DEPARTMENT OF TRANSPORTATION

Contract #: 04-0120F4Cty: SF/ALA Rte: 80 PM: 13.2/13.9File #: 1.28**WELDING INSPECTION REPORT****Resident Engineer:** Casey, William**Address:** 333 Burma Road**City:** Oakland, CA 94607**Report No:** WIR-028637**Date Inspected:** 20-Oct-2012**Project Name:** SAS Superstructure**OSM Arrival Time:** 700**Prime Contractor:** American Bridge/Fluor Enterprises, a JV**OSM Departure Time:** 1530**Contractor:** American Bridge/Fluor Enterprises, a JV**Location:** Job site

Ultrasonic Testing OBG

13E Drop-in Web Splice (Weld No. 13E-PP120.5-E2.1-BW1)

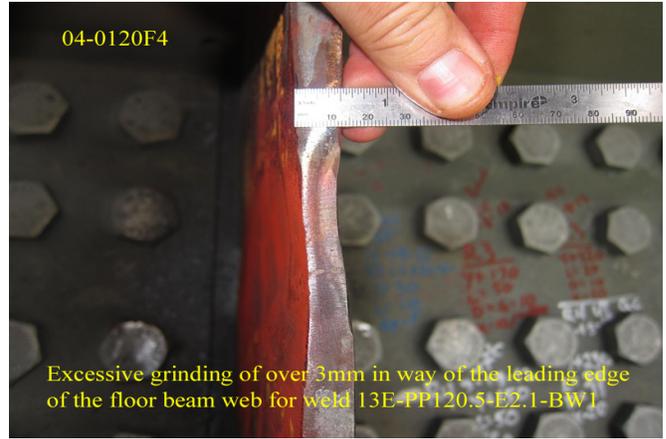
During the QA final visual inspection of this weld the QAI observed excessive grinding of over 3mm in way of the leading edge of the floor beam web as seen in the attached photograph. The ABF QC inspector Salvador Moreno was notified, who then stated that further welding and QC inspection would be done prior to QA final verification.

13E Deck Access Hole Splice (Weld No. DAH-13E-PP124.5-E5)

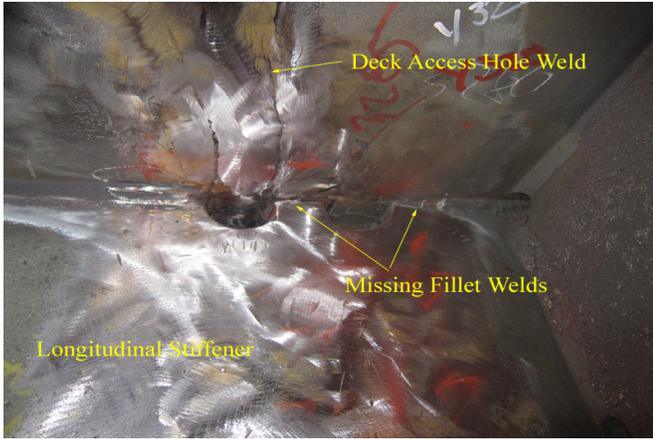
The QAI performed a minimum of 15% random verification of this weld from Face B only. No rejectable indications were observed at the time of inspection however; during visual inspection of this weld the QAI observed missing fillet welds in way of the 485 longitudinal deck stiffener to the deck connection as seen in the attached photograph. The welds appeared to be intentional holdback welds left by the manufacturer to aid in the fit-up of the deck access hole stiffeners. The QAI then reviewed the fabrication drawings and confirmed these locations required fillet welds. The ABF QC Lead inspector Bonifacio Daquinag was notified who then stated he would discuss the issue with ABF management.
